Application for Licence Amendment

Choose an item.	L4680/1988/13
Choose an item.	FMR Investments Pty Ltd
ACN	009 411 349
File Number	2013/003899-1
Premises	Greenfields Processing Site Great Eastern Highway COOLGARDIE WA 6429 Legal description – Part of mining tenement M15/1836 and Lot 102 on Plan 40393 As defined by the Premises maps attached to the Revised Licence.
Date of Report	20 January 2025
Decision	Revised licence granted

**MANAGER, RESOURCE INDUSTRIES
INDUSTRY REGULATION (STATEWIDE DELIVERY)**

Figure 1: TSF3 Cells A, B and C, RL 407.7 m Plan

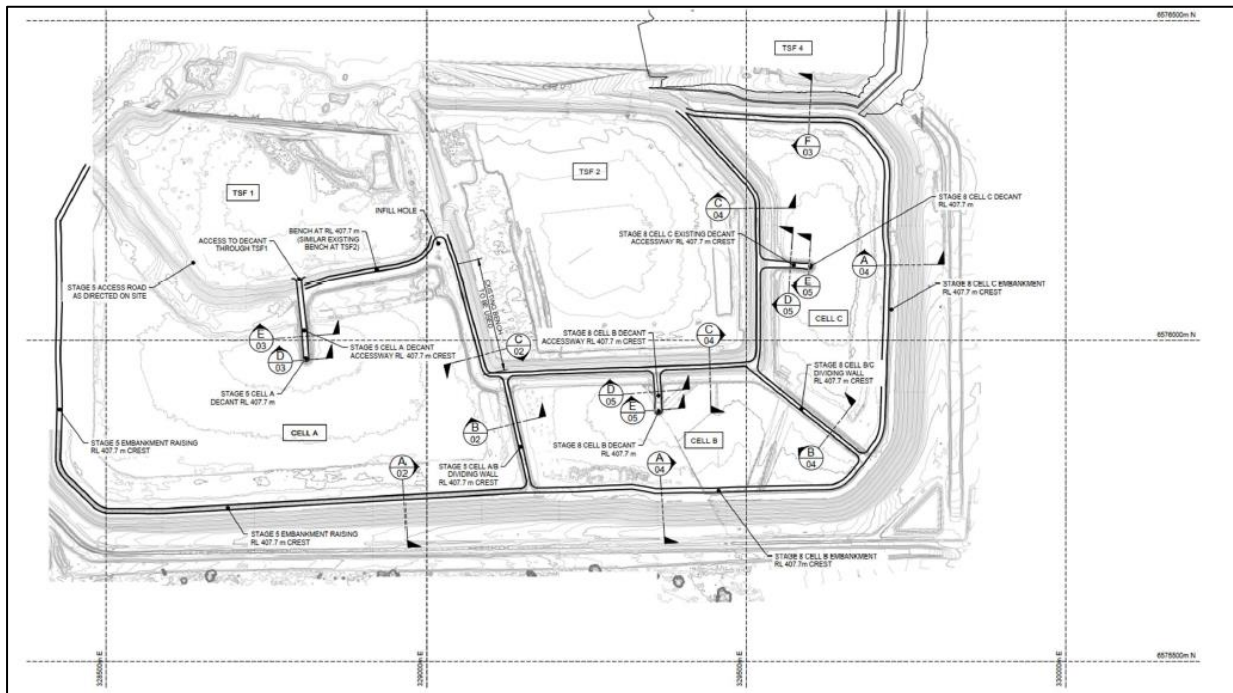
The proposed TSF3 Cell A (Stage 5) and Cells B and C (Stage 8) embankment raises will be undertaken using the upstream construction method by 1 x 2.7 m lift. TSF3 Cell A (Stage 5) and Cells B and C (Stage 8) will have a crest level of RL 407.7 m, for maximum embankment heights of approximately 15.7 m, 21.2 m and 22.7 m. This provides a combined storage volume of approximately 0.9 m³, equivalent to a storage capacity of 1.3 Mt based on tailings dry density of 1.4 t/m³, tailings beach slope of 1%, and minimum operational and total embankment freeboards of 0.3 m and 0.7 m, respectively.

The proposed embankment raises will be formed on top of both the existing embankment and on the adjacent dried tailings beach. The raising of the embankments will utilise compacted dried tailings borrowed from within TSF3 and the adjacent decommissioned TSF2, and mine waste sourced from other facilities operated by the Licence Holder or the neighbouring mining operations.

Construction works will be undertaken in accordance with the drawings and the construction specification, scope of work and technical specifications prepared by CMW (2024a) (Figure 1).

Figure 3: TSF3 monitoring bore groundwater levels (FMR 2023)

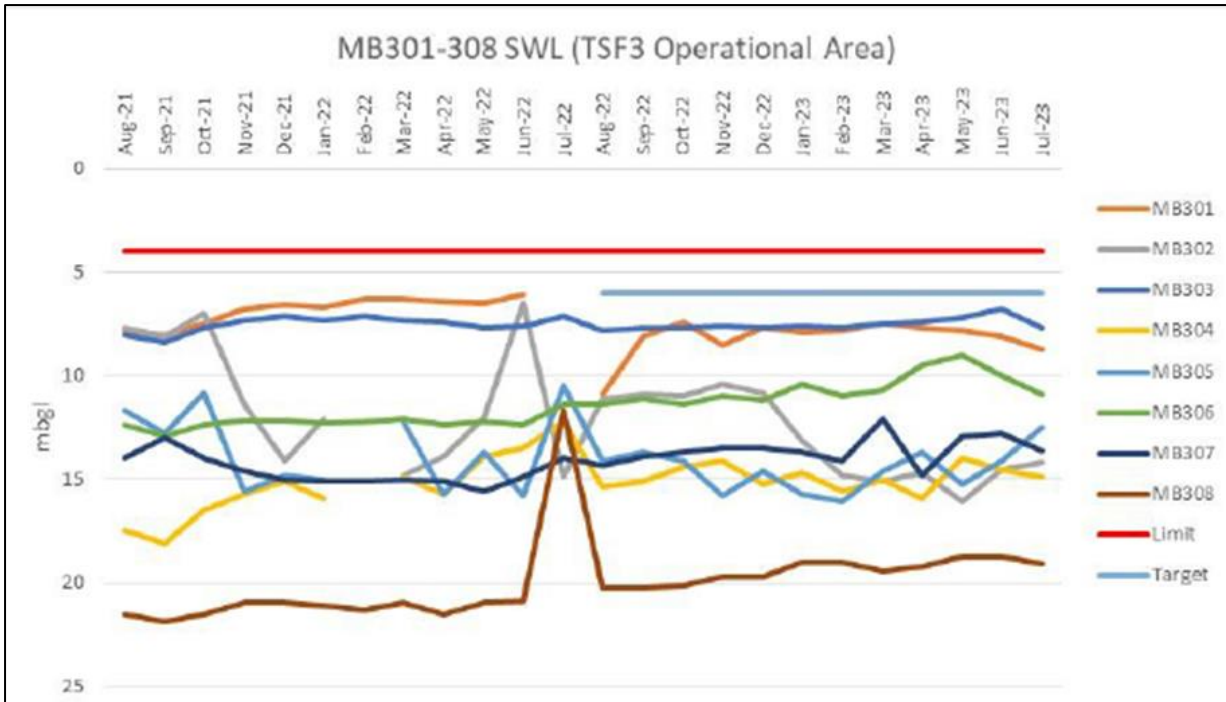
The shallowest groundwater level observed around TSF3 in 2023 ranged between 6.9 mbgl (MB303) and 18.6 mbgl (MB308). In the context of the individual cells at TSF3, the shallowest groundwater levels recorded observed at Cells A, B and C were 6.9 mbgl (MB303), 12.5 mbgl (MB305) and 9.7 mbgl (MB306), respectively. Farther away from TSF3 (i.e., monitoring bores MB309 to MB312), the shallowest groundwater levels ranged between 13.9 mbgl (MB312) and 18.8 mbgl (MB309).

Over time, standing water level at groundwater monitoring bores around TSF3 have remained relatively stable since the 2021/2022 annual period (Figure 3). At the time of this assessment, none of the monitoring bores associated with TSF3 have exceeded the limit of 4.0 mbgl, specified in existing licence L4680/1988/13.

There are no strong indications of groundwater mounding observed at any of the monitoring bores immediately adjacent to TSF3. The only exception is monitoring bore MB308, which is located north-east of TSF3 Cell C and near the interface between TSF3 and TSF4. While the SWL at MB308 appears to be rising over time, it is unlikely to impact neighbouring native vegetation as it is still relatively deep.

Figure 4: Annual seepage bore water recovery amounts (FMR 2023)

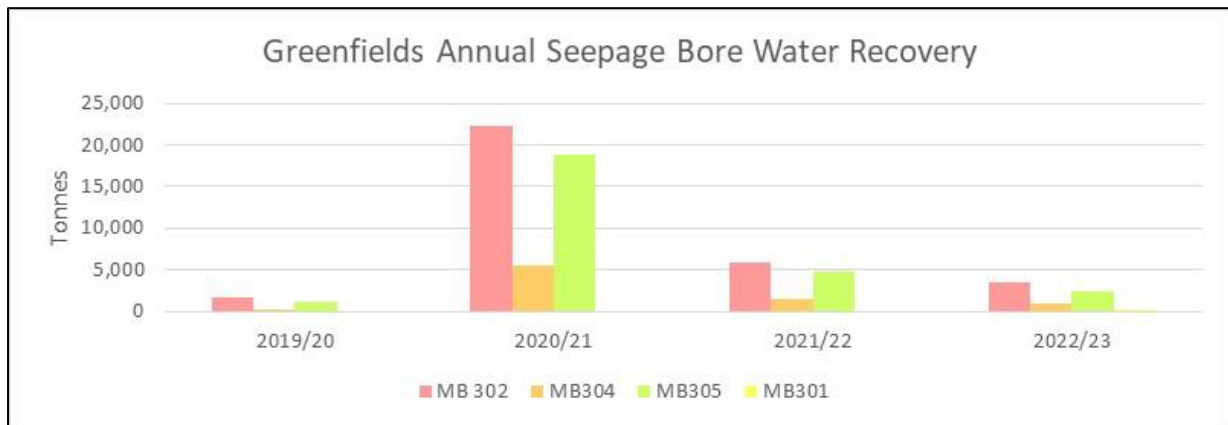
The four sumps, along with three converted monitoring bores, were utilised as part of the TSF3 SMP in response to previous incidents where the relevant SWL limits were exceeded at TSF3. The annual seepage bore water recovery volumes at Greenfields from 2019/20 to 2022/23 are shown in Figure 4. The implementation of the SMP and undertaking of groundwater recovery coincides with the stabilisation of SWL observed at the monitoring bores associated with TSF3.
